## PLAN COMMISSION

### OFFICIAL NOTICE & AGENDA

A meeting of the Town of Rib Mountain Plan Commission will be held on **Wednesday, July 11<sup>th</sup>, 2018; 6:30 P.M. at the Town of Rib Mountain Municipal Center, 3700 North Mountain Road.** The Town Board may attend for purposes of gathering information. Subject matter for consideration and possible action follows:

**FROM:** Steve Kunst, Community Development Director  
**DATE:** July 5, 2018  
**SUBJECT:** General Development and Precise Implementation Plan Review

**LANDSCAPE PLAN**

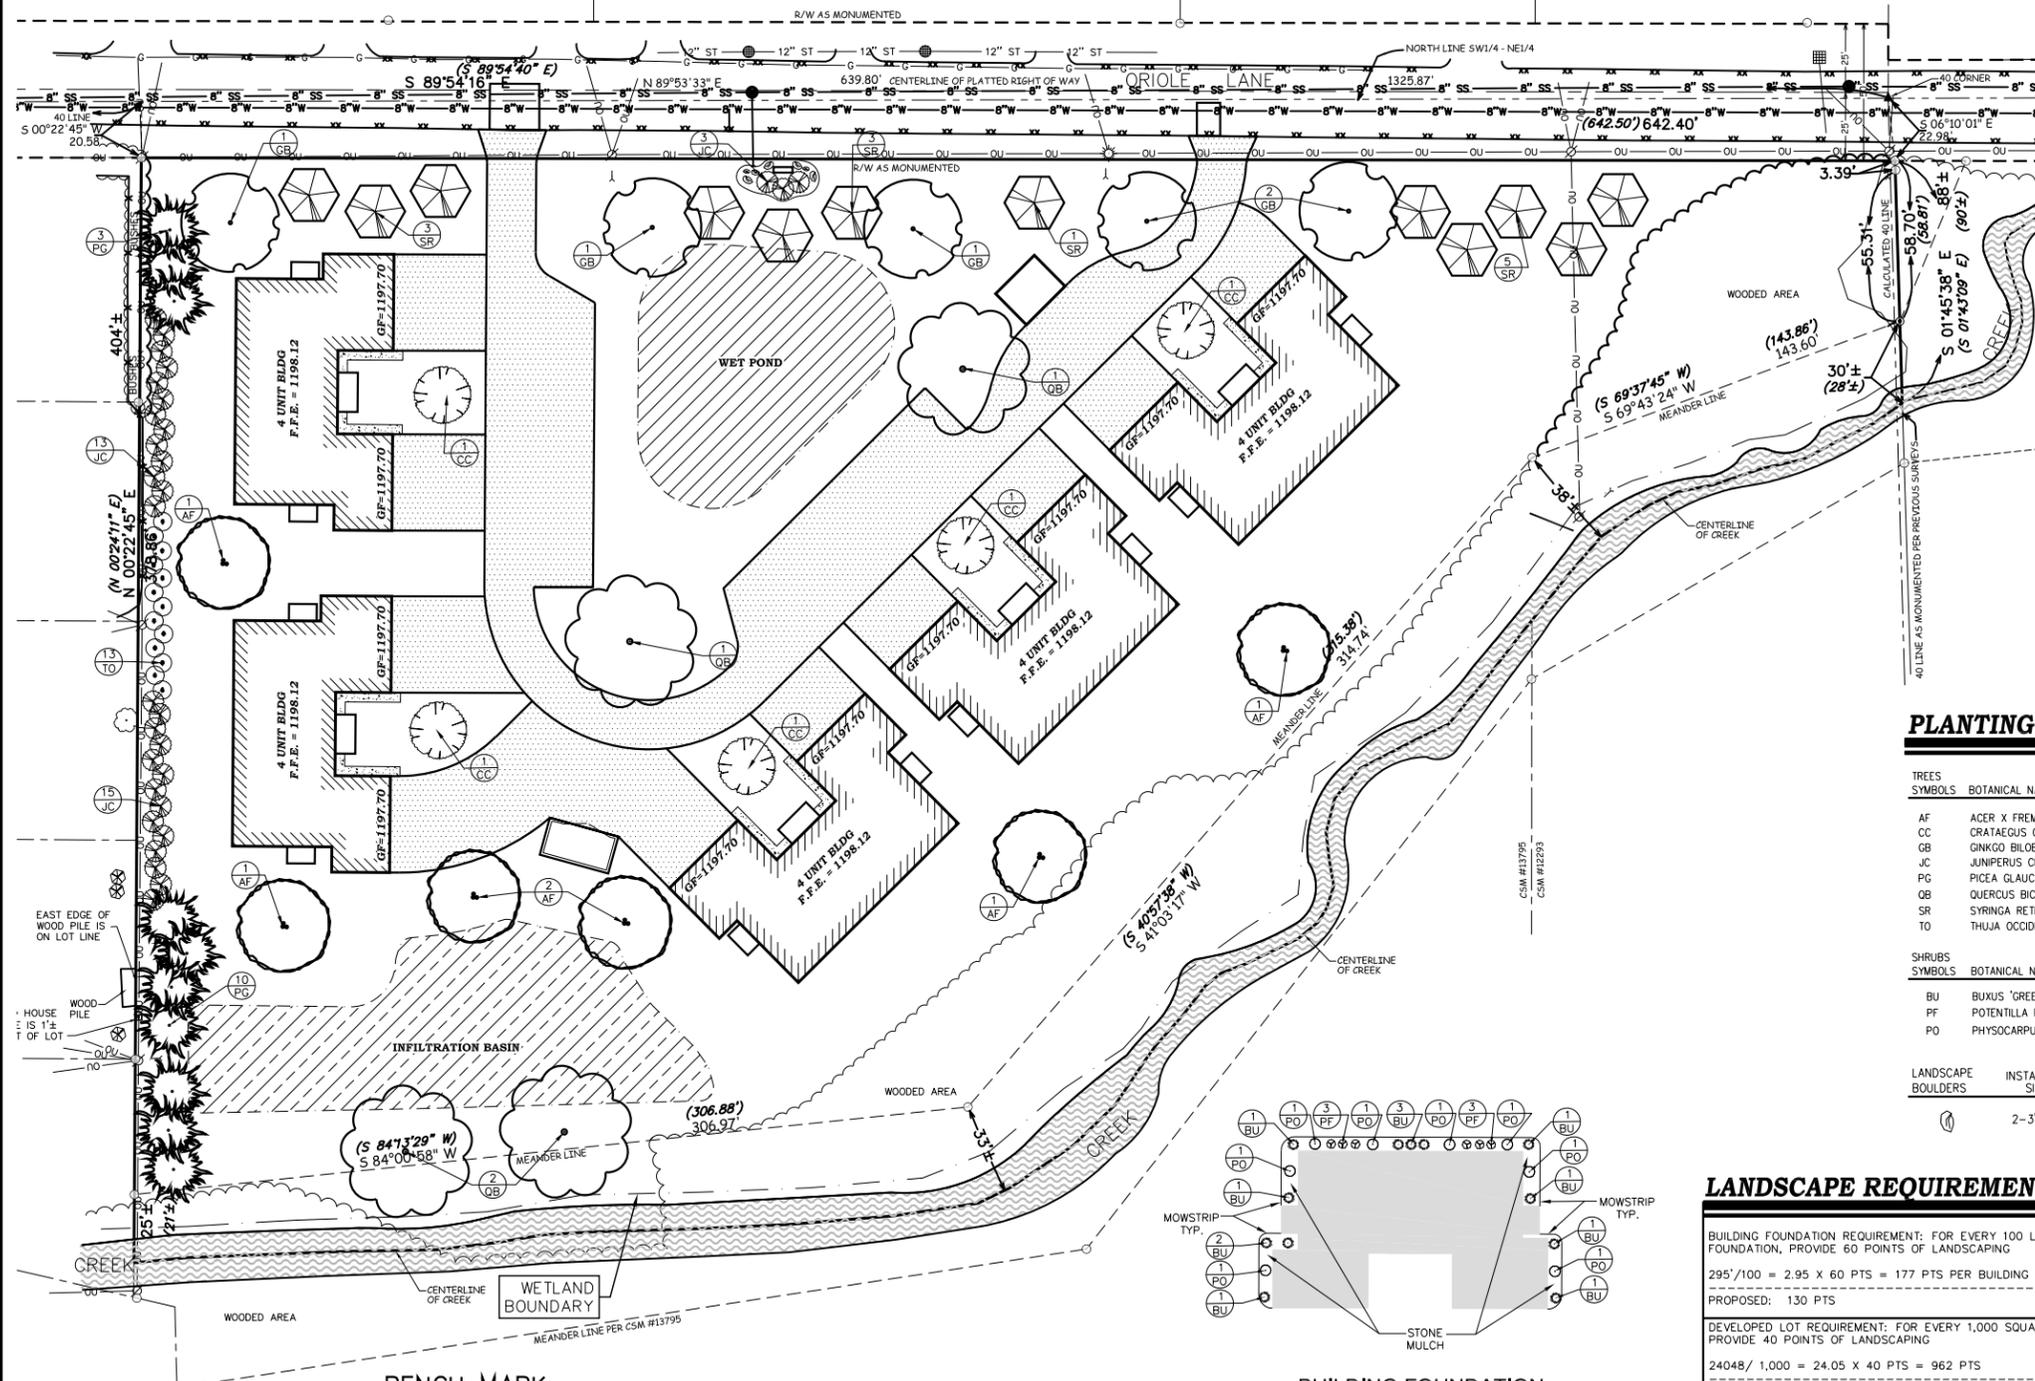
**BUILDING FOUNDATION REQUIREMENT:** FOR EVERY 100 LINEAL FEET OF BUILDING FOUNDATION, PROVIDE 60 POINTS OF LANDSCAPING  
 295'/100 = 2.95 X 60 PTS = 177 PTS PER BUILDING X 5 = 885 PTS REQUIRED  
 PROPOSED: 130 PTS

**REQUIREMENT:** FOR EVERY 20 PARKING STALLS OR 10,000 S.F. OF PARKING AREA (WHICHEVER IS GREATER) PROVIDE 120 POINTS OF LANDSCAPING  
 40 PARKING SPACES/20 = 2 X 120 PTS = 240 PTS  
 OR  
 30,048 S.F. OF PARKING AREA/10,000 S.F. = 3.00 X 120 PTS = 360 PTS REQUIRED  
 PROPOSED: NO PARKING AREA LANDSCAPING PROPOSED
